Re: Woodlake Center

POADP # 636

#### P.O.A.D.P REVIEW

Woodlake Center Subdivision Located on FM 78 @ North Foster Road

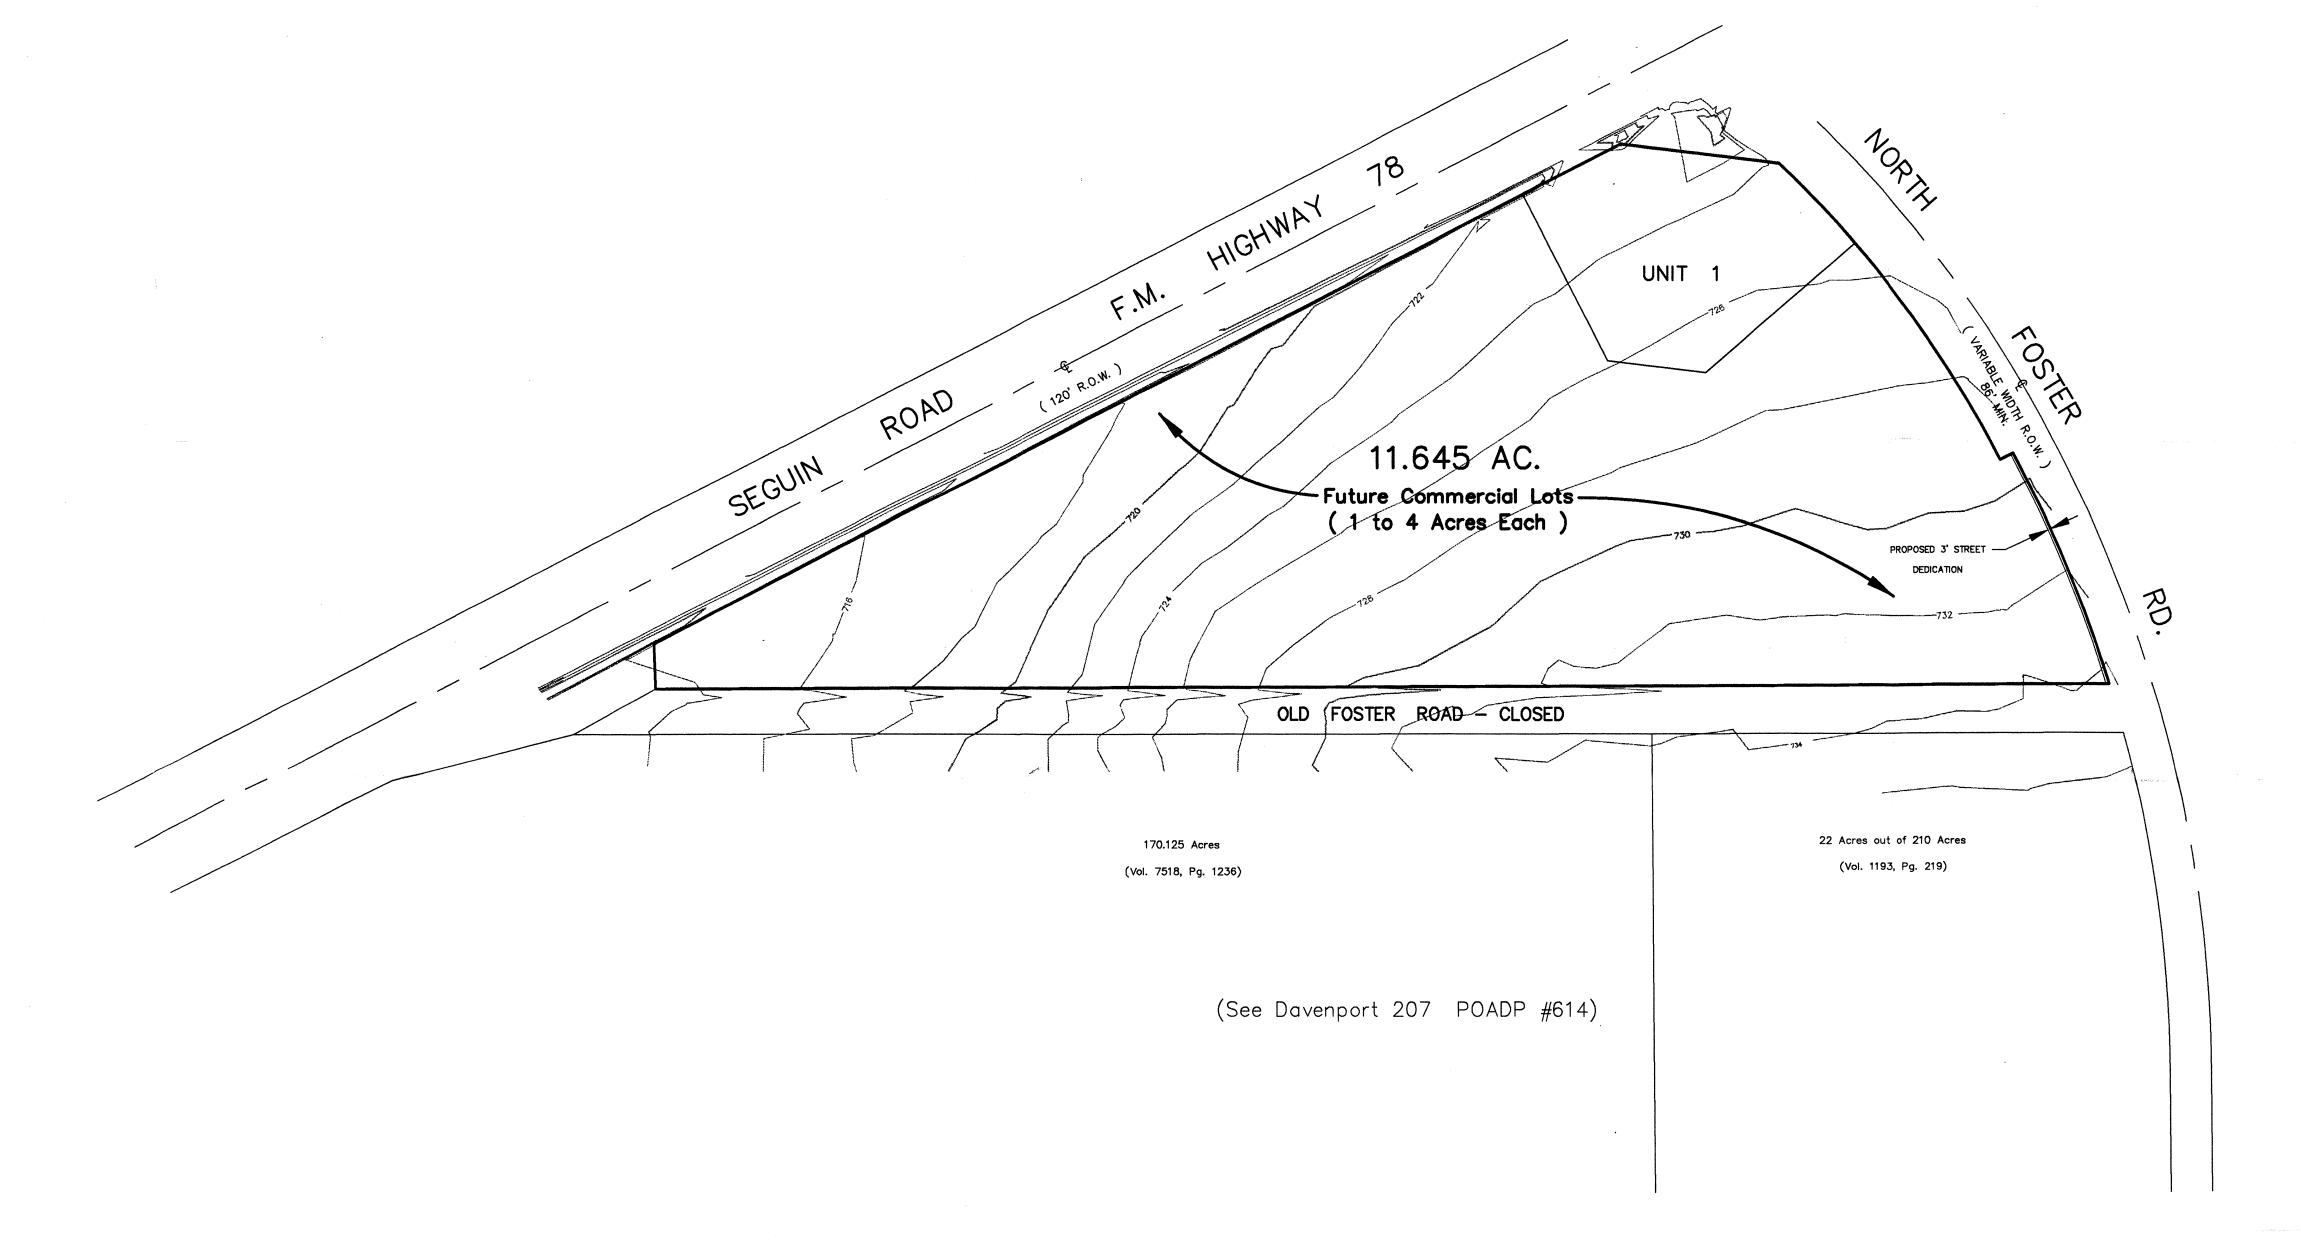
- Based on the topography, a Flood Plain Study and drainage review will probably be required during the platting process.
- Access and R.O.W. issues along State facilities will need to be resolved with the Texas Department of Transportation (TXDOT). For information about these requirements contact TXDOT at 615-5814.

- This development will need to comply with tree preservation ordinance #85262. For information about these requirements you can contact Building Inspections at 207-7102.

- It will be expected that you will plat all of the property depicted in your POADP, to include: floodpains, drainage areas and open space.
- A one foot non-access easement will be required at the corner of North Foster Road and Seguin Road. This easement will need to include the entire corner, plus fifty feet on either both sides.

- I would encourage you to work closely with the school district, so that they can plan accordingly.
